This letter is to address your comments dated June 15, 2015, for the Meijer Curbside program, located at 2811 London Groveport Road, Application #01506010037.

Meijer Store #234
2811 London-Groveport Road
Grove City, OH 43123

Special Use Permit Application:
Canopies and Site Changes to Emphasize Buy Online/Pick-up In Store Program (BO/PIS)

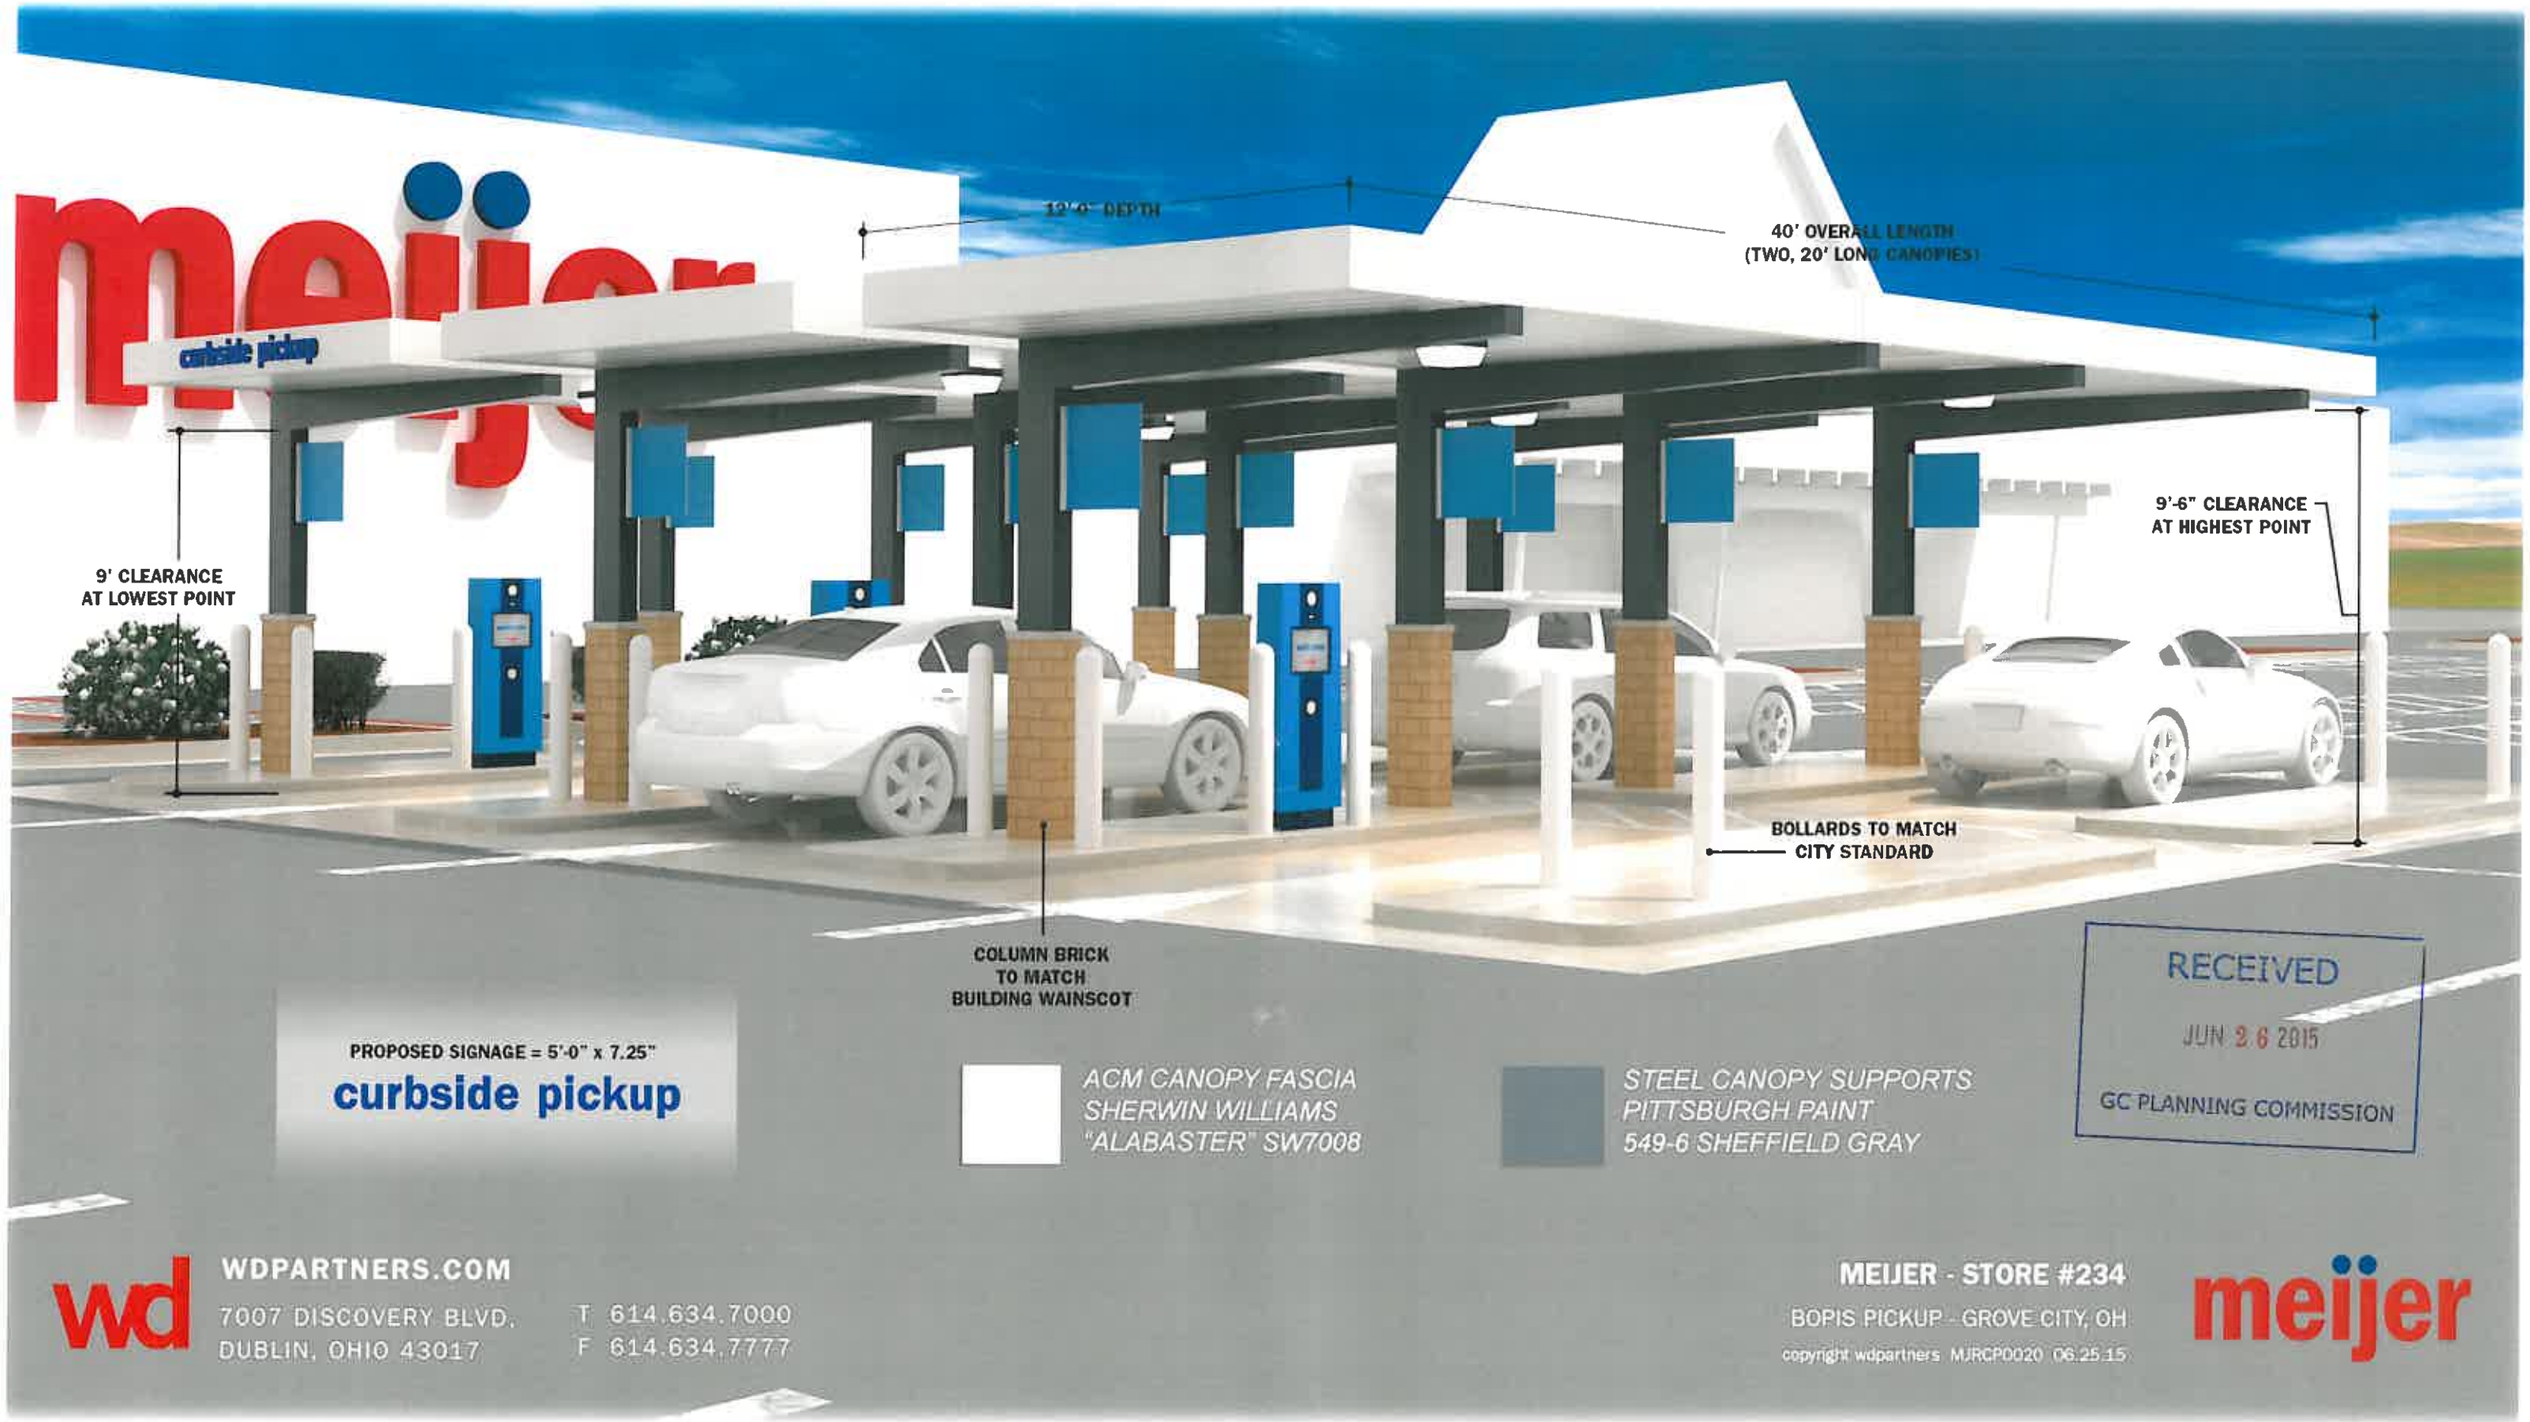
3. All pavement markings should be white.

5. Canopy pillars should be finished in brick matching the primary structure.

6. The roofline of the proposed canopies should be decorative, similar to the roofline of the gas station canopy.

Pavement markings have been updated and are shown on the rendering.

Brick has been added to the canopy pillars.

As mentioned previously, we prefer to prefer to keep the existing canopy structure as proposed. The canopy is a single manufactured piece that is pressed out during fabrication. Adding extra detail to the canopy may render the project cost prohibitive.

C1.0

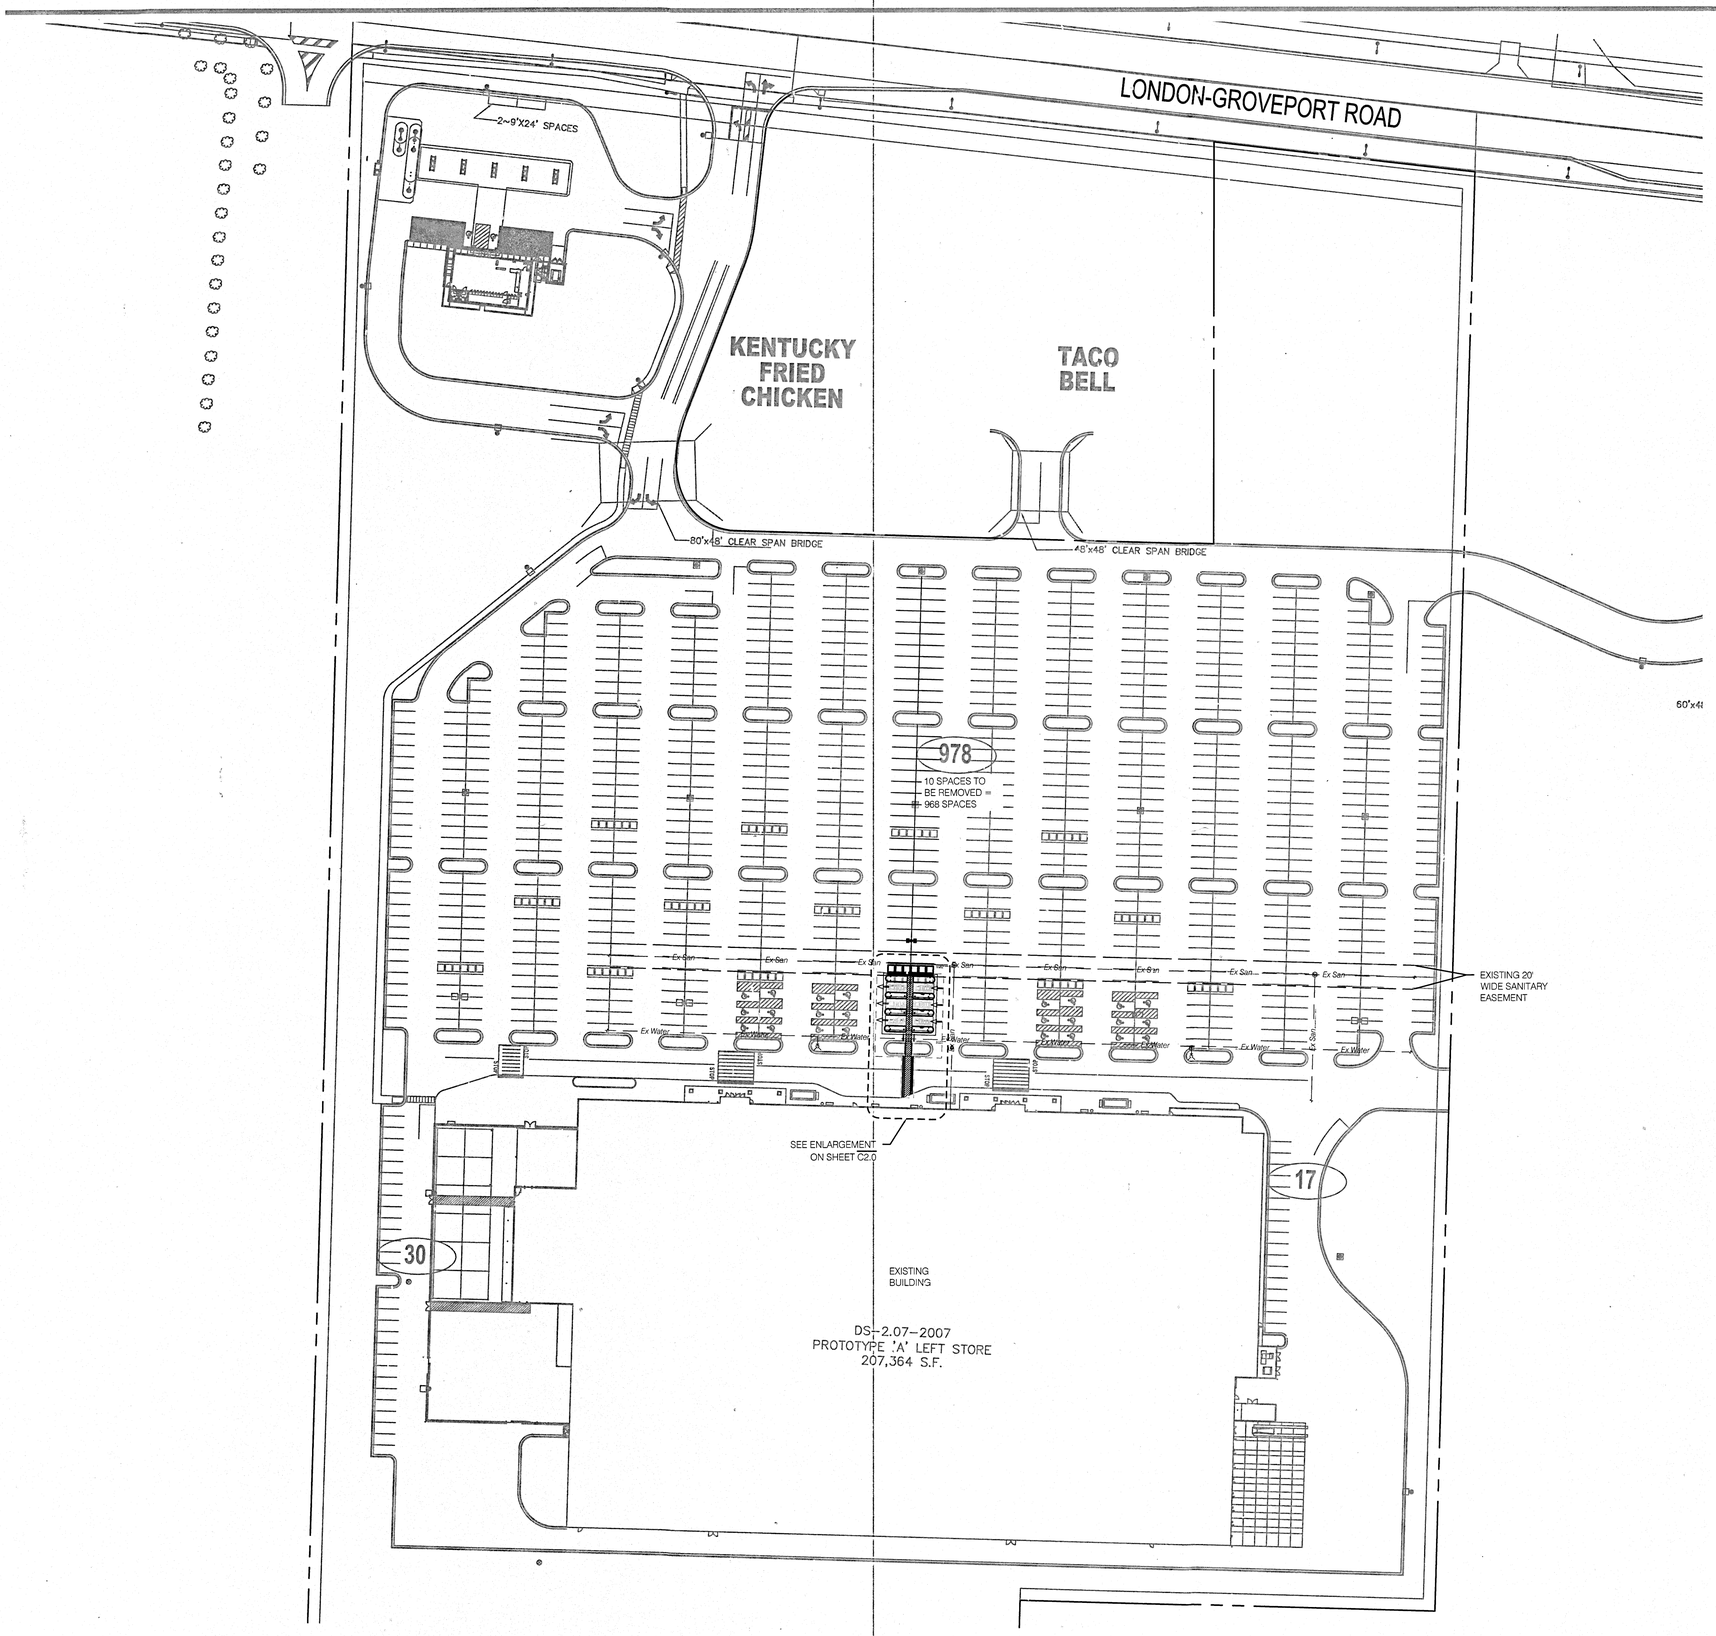
2. The current location of the handicap parking is not shown correctly on sheet C1.0. The handicap spaces do not flank the eastern crosswalk, but are instead located west of the drive aisle proposed for the pick-up bays. If the parking lot is to be restriped according to plans, plans should state this.

Sheet C1.0 has updated to reflect the changes.

STAMPED CONCRETE DETAIL
SCALE: NONE

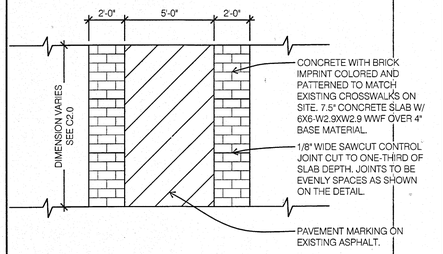
4. The crosswalk to access the pick-up bays should be bordered by stamped brick, matching the existing crosswalks on the site.

The crosswalk will be stamped brick to match existing.

DECORATIVE BOLLARD DETAIL
SCALE: NONE

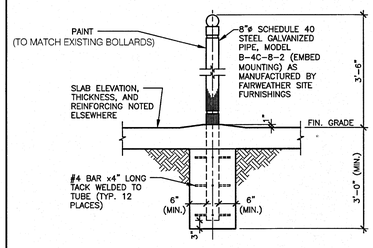
1. Proposed bollards should be decorative to match those utilized on the existing site (details from approved Meijer development plan attached).

We will install decorative bollards to match existing.
